February 2, 2024
Updated March 7, 2024

To: Mr. Mark Oram
Sherborn BOH
19 Washington Street
Sherborn, MA 01770

Please be advised that the application and septic system design plan for 65 Farm, Road, Sherborn, MA, dated 11/30/2023, received by our office on 12/12/2023, and subsequently reviewed with the engineer and peer reviewer, have been found to be deficient based on the following deficiencies or missing information:

Appendix Supplementary Data for Groundwater Mounding Analysis and Updated Groundwater Mounding Analysis

Table S2. Summary of soil texture analysis based on sieve analysis, 65 Farm Rd, Sherborn, MA

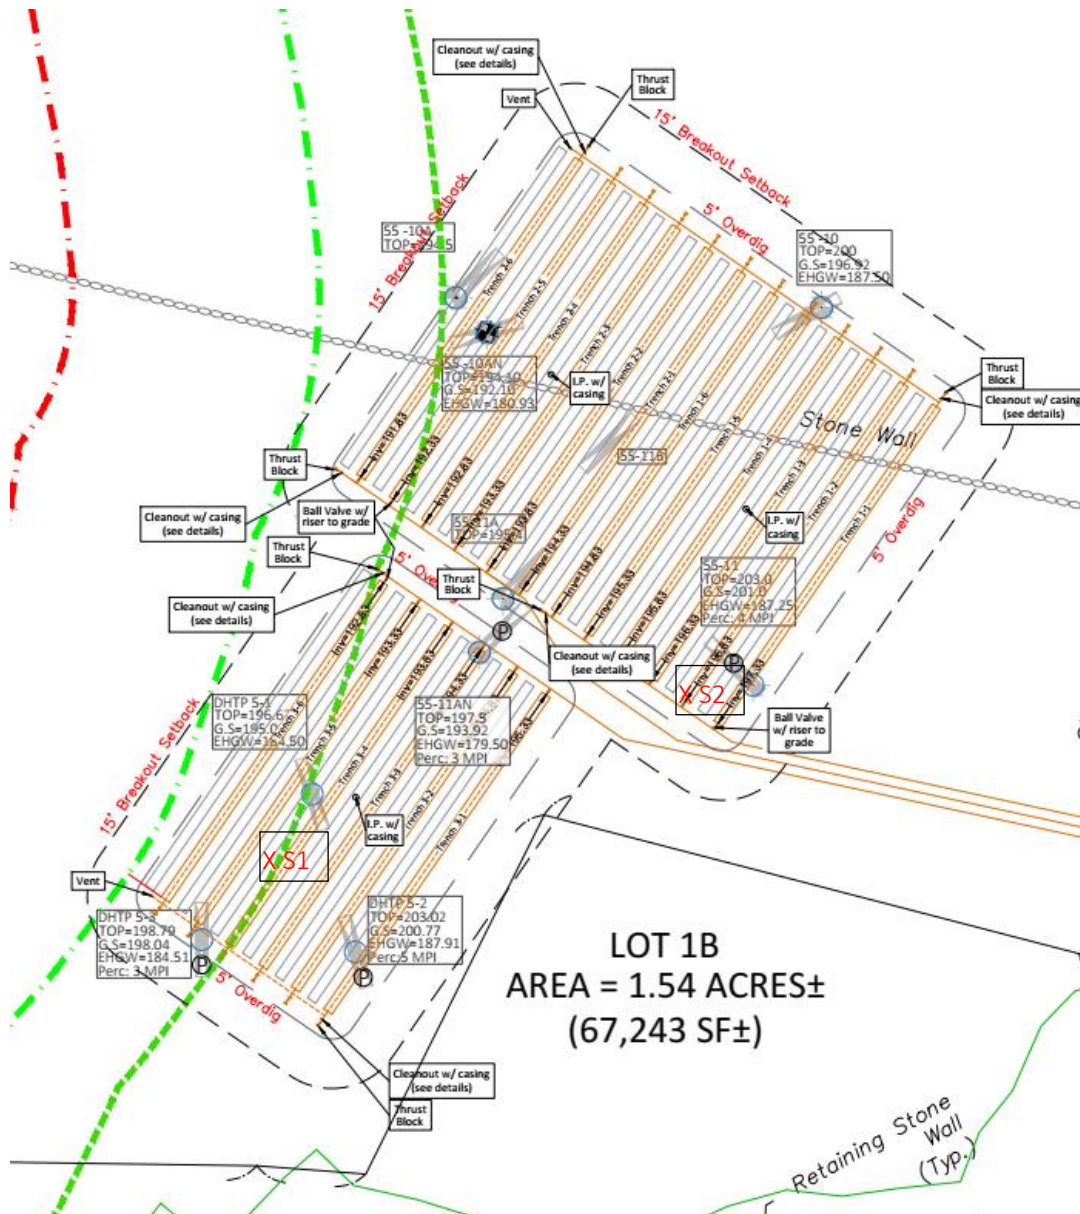
To address the peer review comments regarding the determination of the input parameters, specifically, the saturated soil (unconsolidated aquifer) depth and the hydraulic conductivity (permeability of the soils), we had a meeting on December 20, 2023 with Mr. Peter Dillon, a Hydrogeologist of Tetra Tech and Mr. Mark Oram of the Board of Health Agent.

1. We showed that the nearby well drill logs (49, 53 and 55 Farm Road) were carefully evaluated and found that the well at 53 Farm Road is consistent with the area of the proposed SAS. The saturated soil thickness of 14.5 ft will be used to update the groundwater mounding analysis. This number is very consistent with the deep hole soil testing data. Given that the mounding will spread hundreds of feet, the aquifer depth is conservatively quantified as further downstream the aquifer depth will be thicker. 49 Farm Road well has 25 ft soil over ledge and about 22 ft of saturated soil. See Table S1 for a summary of the well condition. The over 10 gpm yield in all three wells also indicated that the aquifer here is very consistently productive and permeable. The man-dug isolated wet pond on 65 Farm Road has a depth of 15 ft under normal high water, therefore the saturated soil aquifer depth will be at least 15 ft.

2. We also showed that the hydraulic conductivity in documented literature for loamy sand condition is consistent with what we used. See attached extract from a book of soil and rock properties. Mr. Dillon recommended that we take two soil samples from the SAS area to do a grain size sieve analysis, which would accurately confirm the soil texture and provide data for permeability analysis. On January 3, 2024, we took two soil samples witnessed by Mr. Oram from the upper limit of the SAS and down gradient limit of SAS. The two samples together with four soil samples taken from the four proposed stormwater management basins were delivered to Yankee Engineering Testing for sieve analysis. The sieve analysis showed that the soil at the lower limit (S1) is coarse medium sand and the soil at the upper limit of the SAS (S2) is loamy sand. This is consistent with general geological observations, soil in upper hill tends to be well mixed siltier condition than the lower flattened area. And the site has a general deep groundwater condition is another collateral evidence of the well drained soil condition. Out of six soil samples, only one soil was tested sandy loam that is close to loamy sand in upper hill area for stormwater Basin A. Three of them are actually sand and two are loamy sand. See Tabe S2 for a summary and attached lab report for details. Based on the grain size distribution, we calculated the permeability of all six soil samples using two methods: Hazen and Kenny. The result is summarized in Table S3.

Location of soil samples in SAS area

Plan Title: Groundwater Contours

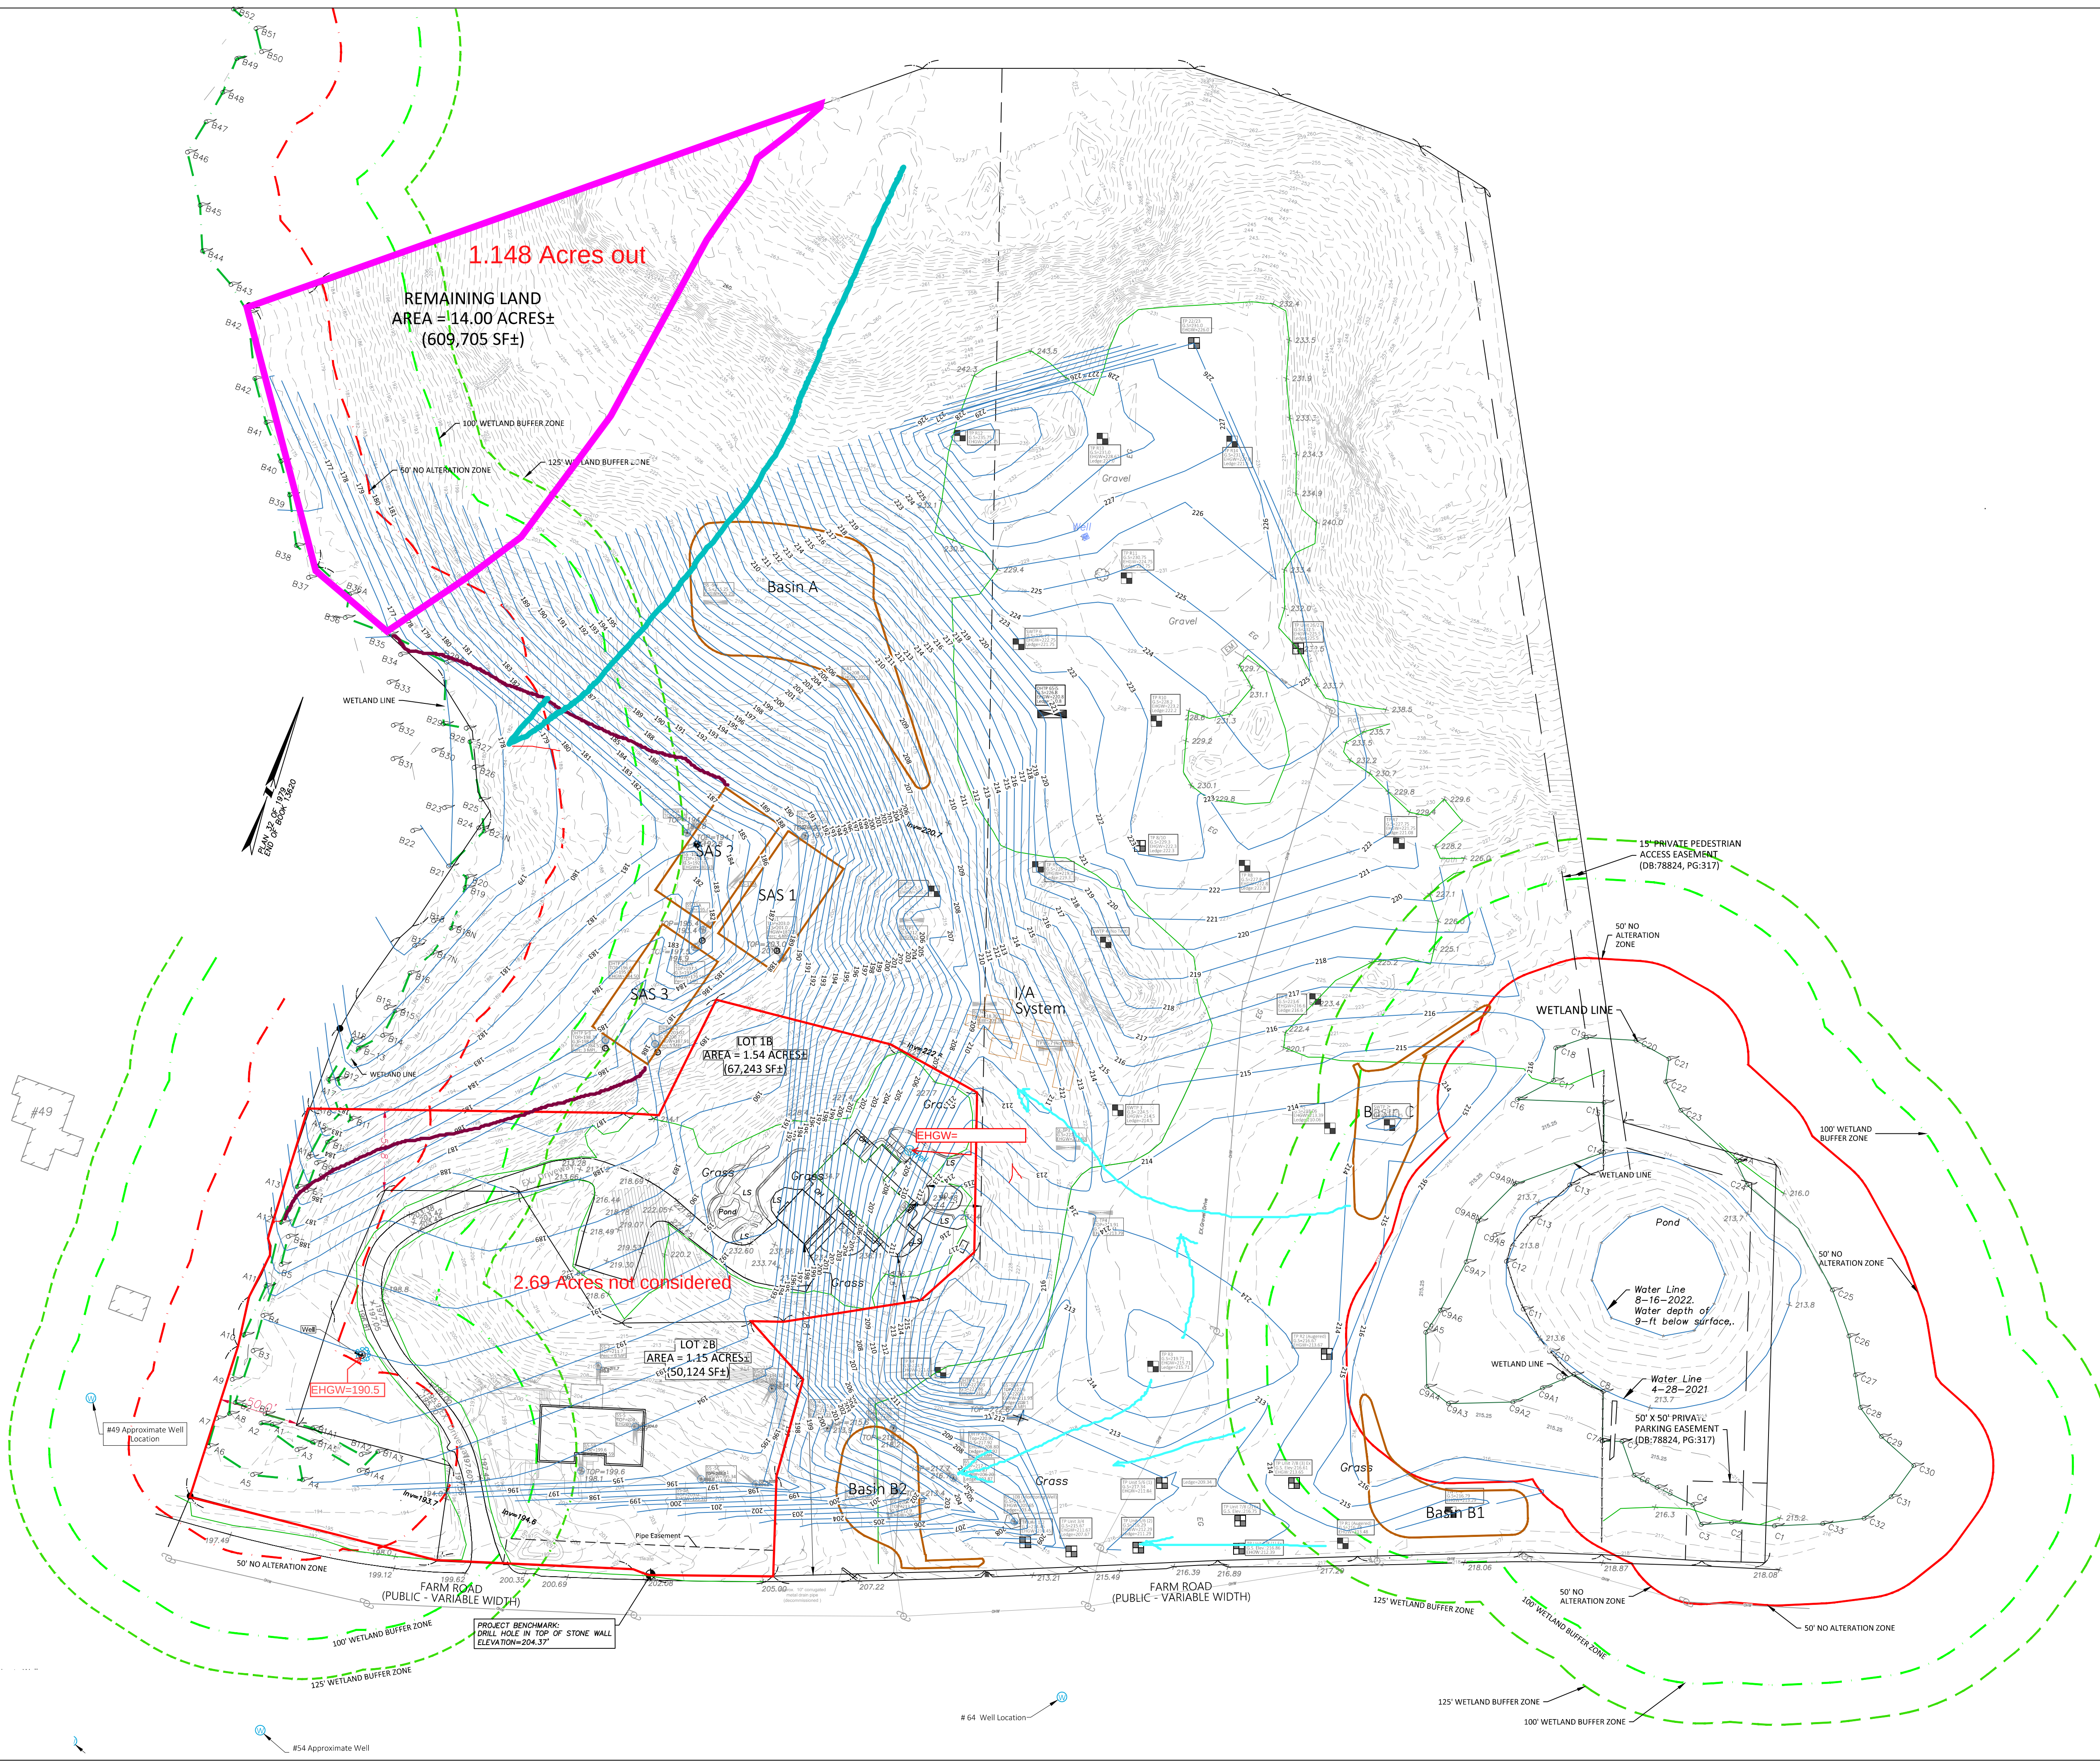
e. *The soil testing on sheet 4 of 9 does not match the Health Agent's soil testing logs. The engineer was sent these soil testing logs on 12/20/2023. On 1/11/2024, the engineer noted that he has not had the opportunity to review those soil testing logs.*

It can be seen that there will be at least 7.17 ft groundwater separation assuming the high groundwater is at the dry test pit bottom. It will be at least 8.29 ft if the water table is based on the observed water tables in the two wet wells.
